Pre-Application Consenting Memo

Pre-Application No. PRR00041653		
Date of request	8/5/2024	
Customer	Century Group Limited	
Contact details	Phone	Anthony James Blomfield: 0211339309
	Email	ablomfield@bentley.co.nz
Site address	440 Mount Wellington Highway Mount Wellington Auckland 1060	
Proposal	S127 variation to reduce the dwell time of the existing northern digital billboard 'a' located at the north-west corner of the site 440 Mount Wellington Highway from 30 sec to 8 sec in the following timeframes: - between 6am and midnight on weekdays, and - between 10am and midnight on weekends.	
Plans and information	Available at the meeting: - Approved Plans LUC60326896-A - Memo Re: Jaafar Holdings Limited, 440 Mt Wellington Highway, Mt Wellington, Existing Digital Billboard Dwell Time Assessment, dated 17 July 2024, by Harries Transportation Engineers Ltd (enclosed in Attachment 2) Supplied after the meeting: - Memo Re: PRR00041653: Jaafar Holdings Limited, Digital Billboard Dwell Times - 440 Mt Wellington Highway, Mt Wellington, dated 8 Aug 2024, by Harries Transportation Engineers Ltd (enclosed in Attachment 3)

Fig 2. The subject billboard location, shown as 'northern billboard'

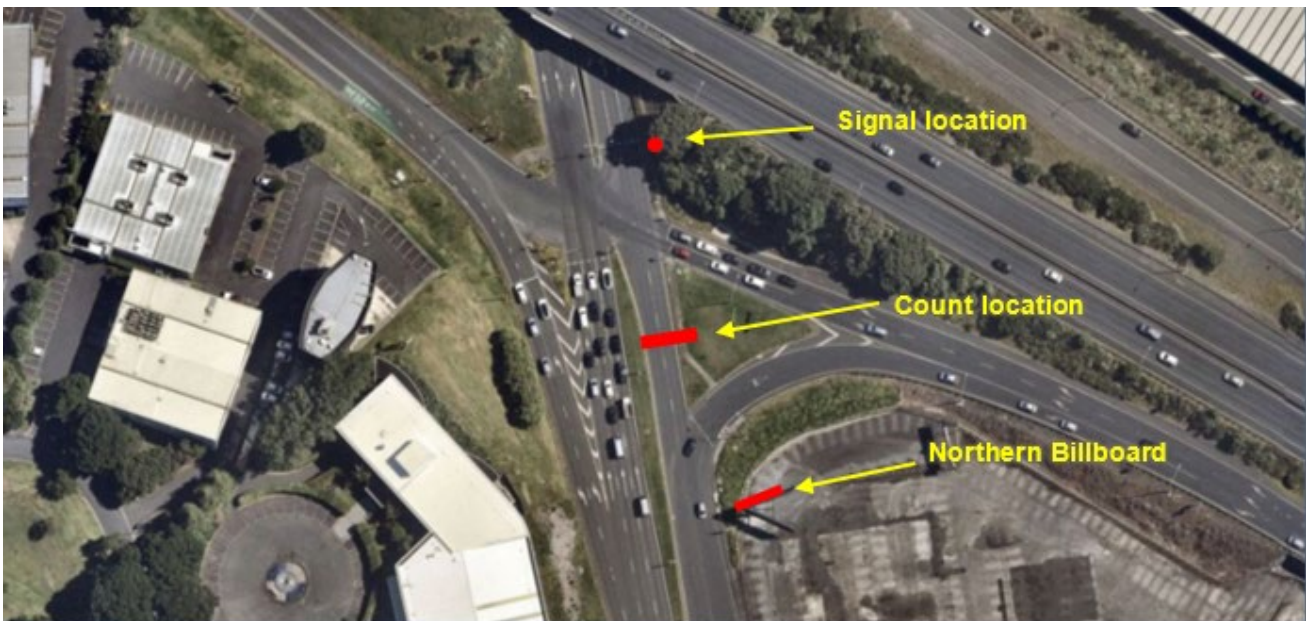
- Mr Shen and Mr Schischka both raised safety concerns on the 85th percentile vehicle travel speed (54 km/hr) provided from the speed counts analysis. This is faster than the anticipated speed in this location, noting the motorway offramp's speed limit is 50km/hr. Any further reduction of billboard dwell time may have potential negative impacts on traffic safety.

- Mr Shen raised the matter that a dwell time reduction will increase the possibilities of distractions to the drivers. When considering this and the observed vehicle speed and its safety implication, he does not support the proposal to reduce the billboard dwell time further.

• Mr Schischka asked the applicant to provide the source of the crash survivability information contained in the memo. • Mr Schischka raised the higher the vehicle speed, the higher the injury/death rate is, if a vehicular clash were to occur. The survivability for drivers at 55km/h is about 85% (provided in the memo). As per AT's research, the survivability for pedestrians at a crash is 20% when vehicular speed is 50km/h. Considering the potential safety impact, a reduction on billboard dwell time in this location is not recommended. • Mr McGarr responded that the research up-to-date on the billboards and its safety implication to drivers do not suggest that billboards operation and dwell time reduction have negative impact to drivers safety. • Mr Liu questioned the credibility of such research. • Mr Shen raised the frequency of billboard content change will be increased from the proposed dwell time reduction from 30 to 8 sec, therefore the rate of distraction to the drivers is increased accordingly. • Mr Schischka raised distraction at this location may result in the drivers failing to notice traffic light change or failing to change to the correct lanes before entering the intersection, as there is a long distance of overlapping between the billboard and the traffic signal before drivers enter the intersection. • Mr Shen also stated most intersections will have overhang arms to provide additional signal displays to allow drivers to see signal displays at different position even when oversize vehicles block the view of one display, the overhang arm displays are also available. But this intersection is located near by the overbridge, no overhang arm displays are provided, which restricts drivers see additional displays. • Mr Schischka raised concern on the flow-on effect of the crash, i.e. the congestion and delay of traffic movement on the motorway if a crash occurs due to the billboard operation. • Mr McGarr clarified effects assessment must be based on the additional effects arise from the proposed dwell time changes, rather than from the existing billboards as these have been legally established.

Figure 2.7: Relationships between bullet vehicle impact speed and probability of a MAIS 3+ injury to a target vehicle occupant for different crash configurations

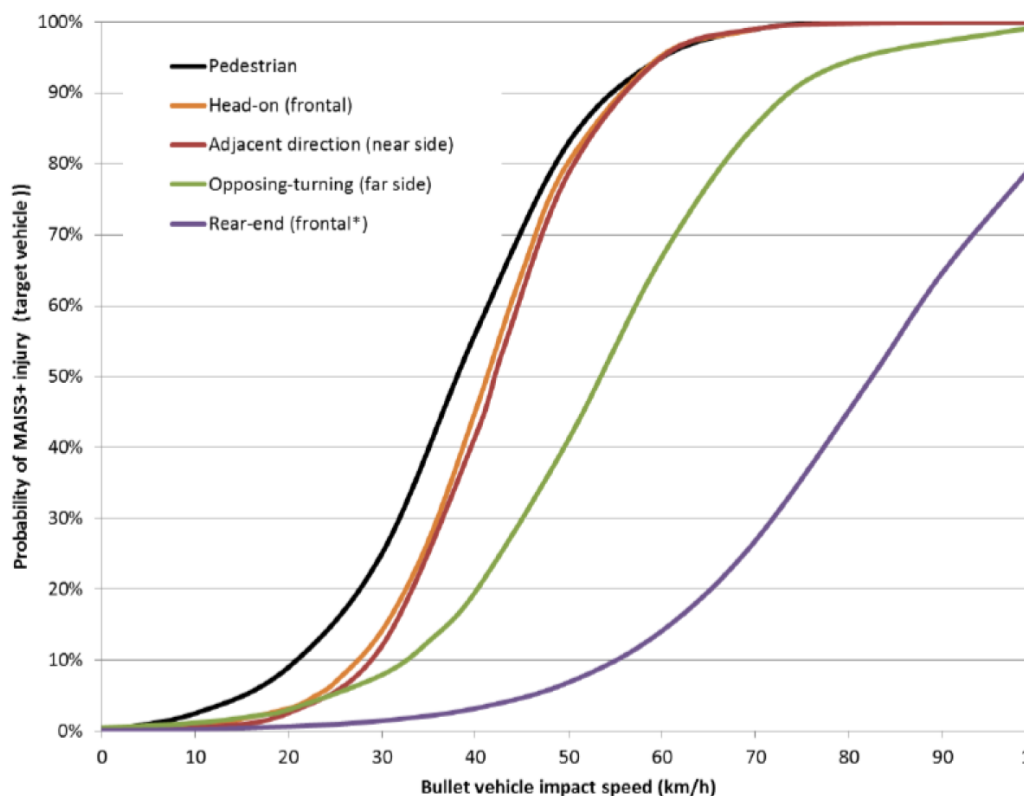
3. Austroads also contains information from later studies regarding the relationship between the likelihood of a serious injury crash, vehicle speeds, and the type of crash. Below is an excerpt from Austroads on this. Of particular note is the statement that *“The modelling shows that when considering (serious) injury in addition to fatality risk, the speed thresholds communicated by Wramborg decrease.”*

4. AT is particularly concerned with both fatal and serious injury crashes. If a southbound driver on Mount Wellington Highway (MWH) failed to notice a signal change and entered on a red signal the most likely crash type would be a side impact crash involving a vehicle coming off the motorway off-ramp. At an impact speed of 54 km/h this has a high chance of resulting in a serious injury (or death), especially if the southbound vehicle impacted the driver’s side door of a vehicle coming off the off-ramp. At this site, drivers on MWH southbound do not have good visibility of the off-ramp and cannot see if vehicles on that approach are moving or stopped until they are in the intersection. This means there is limited opportunity for a southbound driver travelling at near 54 km/h to break before a collision.

The modelling shows that when considering (serious) injury in addition to fatality risk, the speed thresholds communicated by Wramborg decrease. For example, the equivalent speeds to those shown previously become 20 km/h for pedestrians, 30 km/h for side impact (near side) and also 30 km/h for a head-on collision.
